PARTS & SERVICE NEWS

REF NO.	AA01228
DATE	October 31, 2001

SUBJECT: RELOCATING CENSE WIRING ON CUMMINS QSK45 & QSK 60 ENGINES AND KOMATSU SSA12V160 & SSDA16V160 ENGINES

PURPOSE: To inform the field of proper instructions for rewiring the 5 volt power supply for the coolant level sensor.

MODIFICATION INSTRUCTIONS

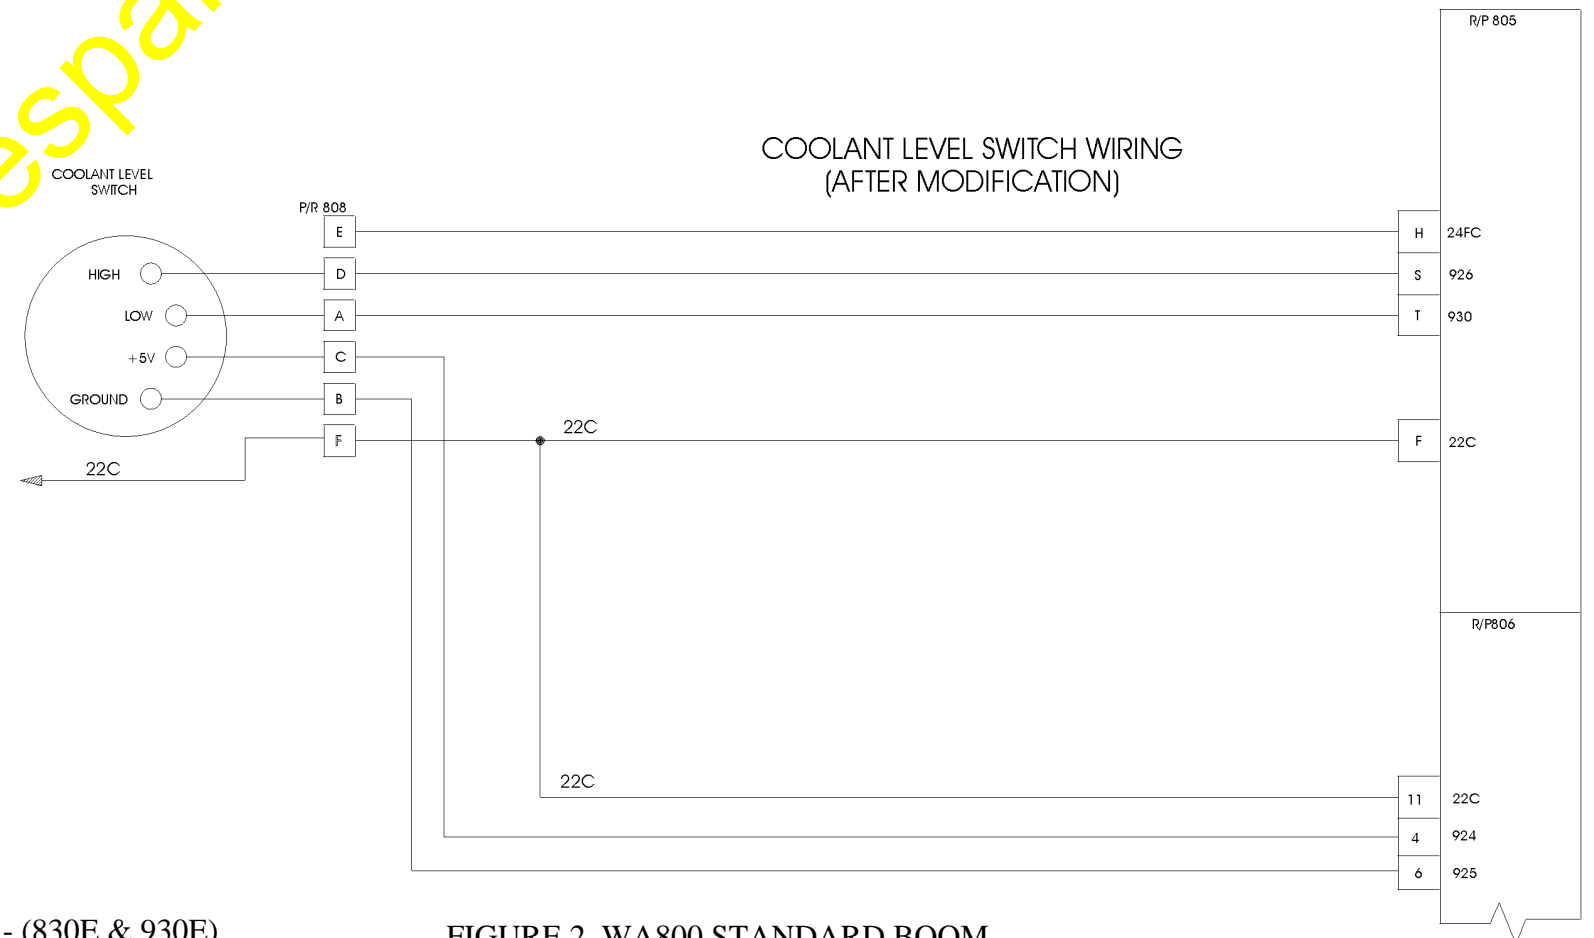
TO PREVENT UNWANTED ENGINE SHUTDOWNS FROM OCCURRING IF THE COOLANT LEVEL 5 V POWER WIRING SHORTS TO GROUND, THE POWER AND RETURN WIRES TO THE COOLANT LEVEL SWITCH MUST BE RELOCATED TO AN ISOLATED 5 V POWER SUPPLY.

THE 924 WIRE MUST BE RELOCATED FROM CONNECTOR R805-U TO CONNECTOR R806-4.

THE 925 WIRE MUST BE RELOCATED FROM CONNECTOR R805-V TO CONNECTOR R806-6.

1. DISCONNECT CONNECTORS R805, R806 AND R808 FROM THE CUMMINS ENGINE ECU. (LEFT REAR OF ENGINE)
2. UNCLAMP THE HARNESS TO GET CLEAR ACCESS TO THE CONNECTORS AND THE HARNESS BODY.

3. CAREFULLY REMOVE THE BRAIDED LOOM FROM THE BRANCHES OF THE HARNESS THAT GO FROM THE MAIN HARNESS BODY TO THE R805 AND R806 CONNECTORS.
4. DISASSEMBLE THE CLAMP AND RUBBER BOOT FROM THE BACK OF THE CONNECTORS AND SLIDE THEM AWAY FROM THE BACK OF THE CONNECTORS TO HAVE ACCESS TO THE PLUGS AND WIRES

5. WITH THE REAR OF THE CONNECTOR R805 TOWARD YOU, SNAP THE EXTRACTION TOOL (P/N VE6051) OVER THE 924 WIRE. SLIDE THE TOOL ALONG THE WIRE INTO THE CONNECTOR UNTIL IT ENGAGES THE CONTACT TERMINAL AND RESISTANCE IS FELT. PULL THE WIRE WITH TERMINAL OUT OF THE CONNECTOR. REPEAT THIS PROCEDURE ON THE 925 WIRE.

6. ON CONNECTOR R806 REMOVE THE SEALING PLUGS (P/N PB5369) FROM POSITION 4 AND 6. INSERT THESE PLUGS INTO THE OPEN PINS U AND V OF CONNECTOR R805. RE-ASSEMBLE CONNECTOR R805.

7. INSERT WIRE 924 INTO CONNECTOR R806 POSITION 4. INSERT WIRE 925 INTO CONNECTOR R806 POSITION 6. RE-ASSEMBLE CONNECTOR R806.
8. USING ELECTRICAL TAPE, START APPROXIMATELY 75 mm. FROM THE BACK OF THE CONNECTOR, AND TAPE THE WIRES TOGETHER COVERING THE REMOVED BRAIDED LOOM AREA OF THE HARNESS.

9. REINSTALL THE HARNESS, START THE ENGINE, AND CHECK FOR ANY FAULT CODES ON THE CUMMINS SYSTEM.

COOLANT LEVEL SWITCH WIRING (BEFORE MODIFICATION)

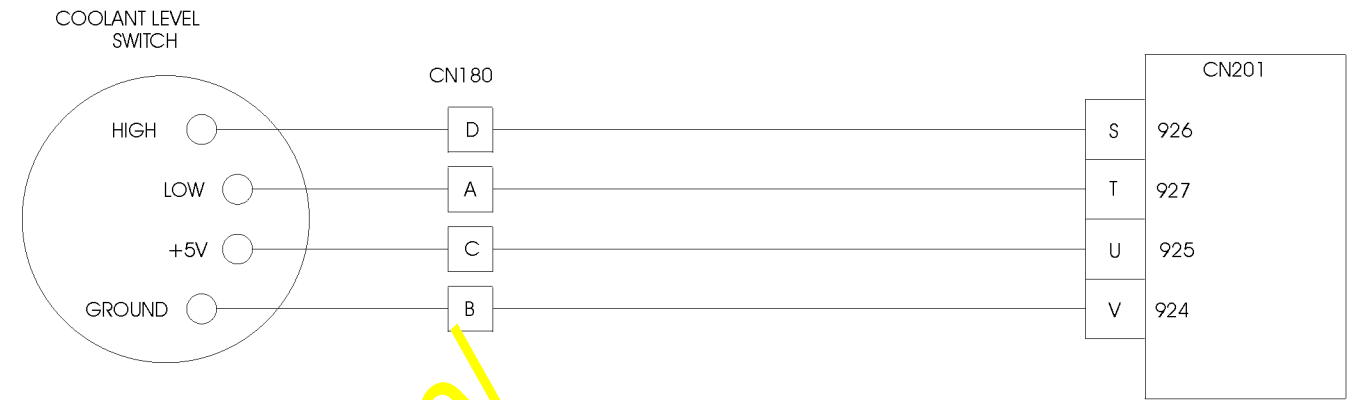
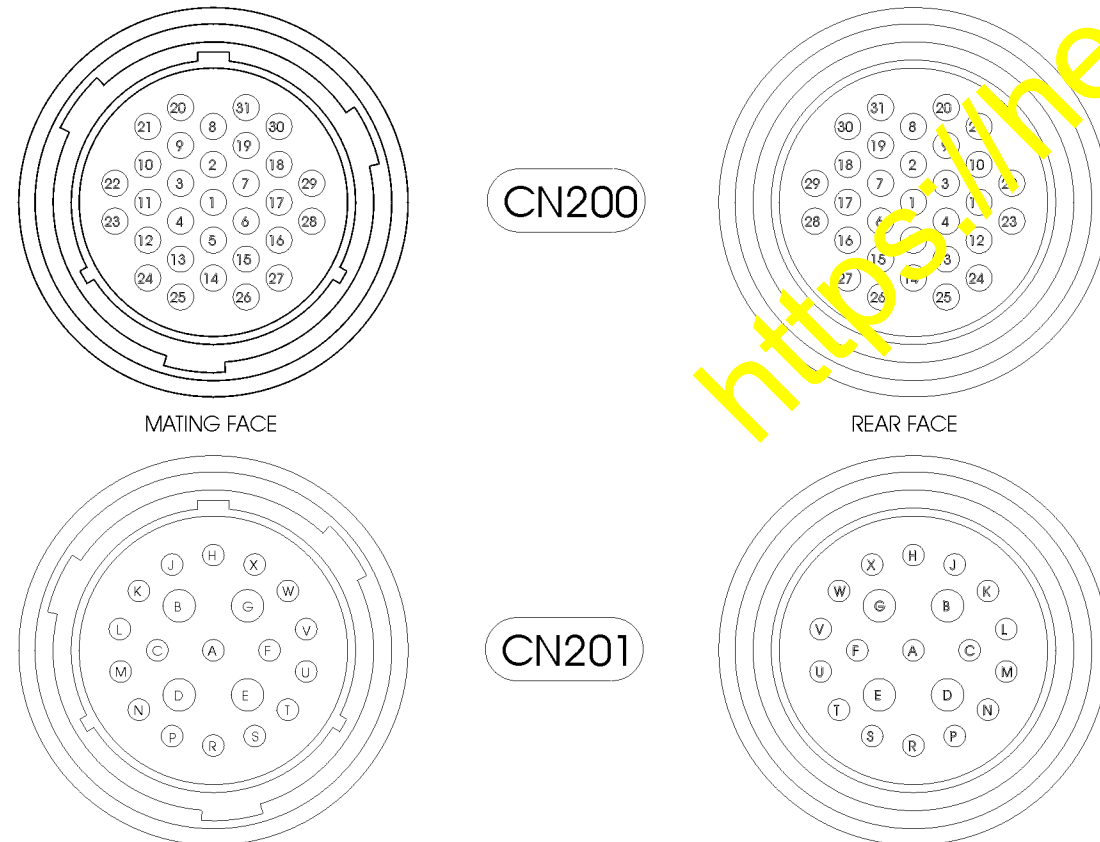
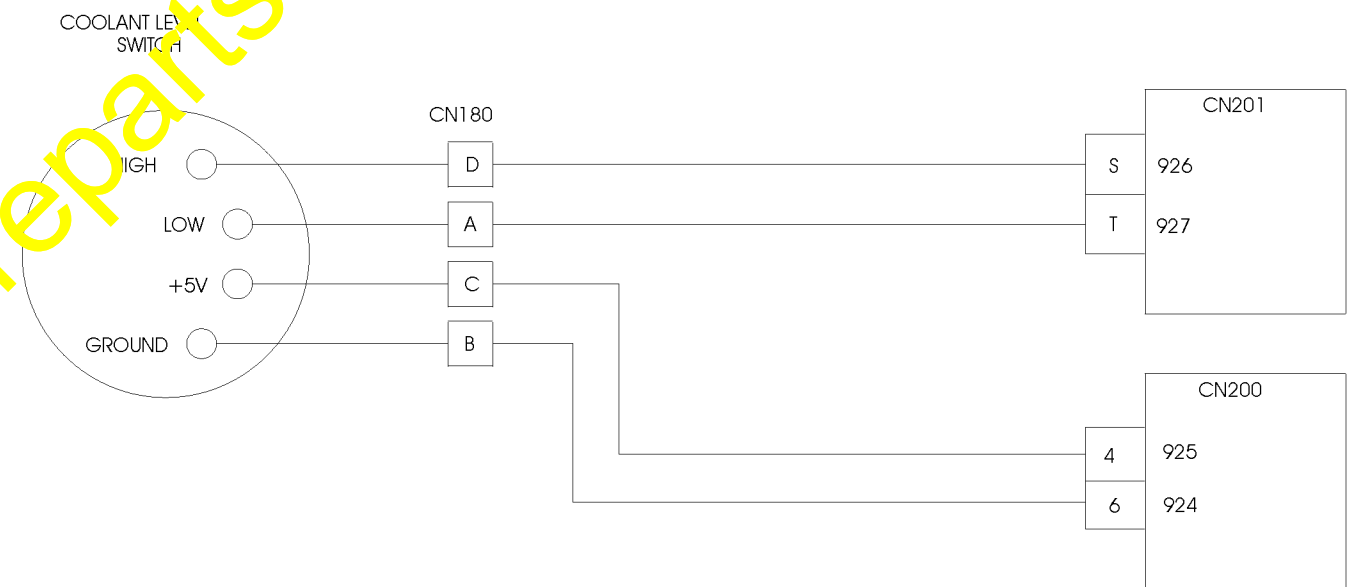
TO PREVENT UNWANTED ENGINE SHUTDOWNS FROM OCCURRING IF THE COOLANT LEVEL 5 V POWER WIRING SHORTS TO THE POWER AND RETURN WIRES TO THE COOLANT LEVEL SWITCH MUST BE RELOCATED TO AN ISOLATED 5 V POWER SUPPLY GROUND,

THE 925 WIRE MUST BE RELOCATED FROM CONNECTOR CN201-U TO CONNECTOR CN200-4.

THE 924 WIRE MUST BE RELOCATED FROM CONNECTOR CN201-V TO CONNECTOR CN200-6.

1. DISCONNECT CONNECTORS CN200, CN201, AND CN203 FROM THE CUMMINS ENGINE ECU. (LEFT REAR OF ENGINE)
2. UNCLAMP THE HARNESS TO GET CLEAR ACCESS TO THE CONNECTORS AND THE HARNESS BODY.

3. CAREFULLY REMOVE THE BRAIDED LOOM FROM THE BRANCHES OF THE HARNESS THAT GO FROM THE MAIN HARNESS BODY TO THE CN200 AND CN201 CONNECTORS.
4. DISASSEMBLE THE CLAMP AND RUBBER BOOT FROM THE BACK OF THE CONNECTORS AND SLIDE THEM AWAY FROM THE BACK OF THE CONNECTORS TO HAVE ACCESS TO THE PLUGS AND WIRES

5. WITH THE REAR OF THE CONNECTOR CN201 TOWARD YOU, SNAP THE EXTRACTION TOOL (P/N VE6051) OVER THE 924 WIRE. SLIDE THE TOOL ALONG THE WIRE INTO THE CONNECTOR UNTIL IT ENGAGES THE CONTACT TERMINAL AND RESISTANCE IS FELT. PULL THE WIRE WITH TERMINAL OUT OF THE CONNECTOR. REPEAT THIS PROCEDURE ON THE 925 WIRE.

6. ON CONNECTOR CN200 REMOVE THE SEALING PLUGS (P/N PB5369) FROM POSITION 4 AND 6. INSERT THESE PLUGS INTO THE OPEN PINS U AND V OF CONNECTOR CN201. RE-ASSEMBLE CONNECTOR CN201.

7. INSERT WIRE 925 INTO THE JIFFY SPLICE (P/N 1259564H1). INSERT THE JUMPER WIRE (P/N CH4145) INTO THE JIFFY SPLICE AND INTO THE CONNECTOR CN200 POSITION 4.

8. INSERT WIRE 924 INTO THE JIFFY SPLICE (P/N 1259564H1). INSERT THE JUMPER WIRE (P/N CH4146) INTO THE JIFFY SPLICE AND INTO THE CONNECTOR CN200 POSITION 6.

9. RE-ASSEMBLE CONNECTOR CN200.
10. USING ELECTRICAL TAPE, START APPROXIMATELY 75 mm. FROM THE BACK OF THE CONNECTOR, AND TAPE THE WIRES TOGETHER COVERING THE REMOVED BRAIDED LOOM AREA OF THE HARNESS.

11. REINSTALL THE HARNESS, START THE ENGINE, AND CHECK FOR ANY FAULT CODES ON THE CUMMINS SYSTEM.
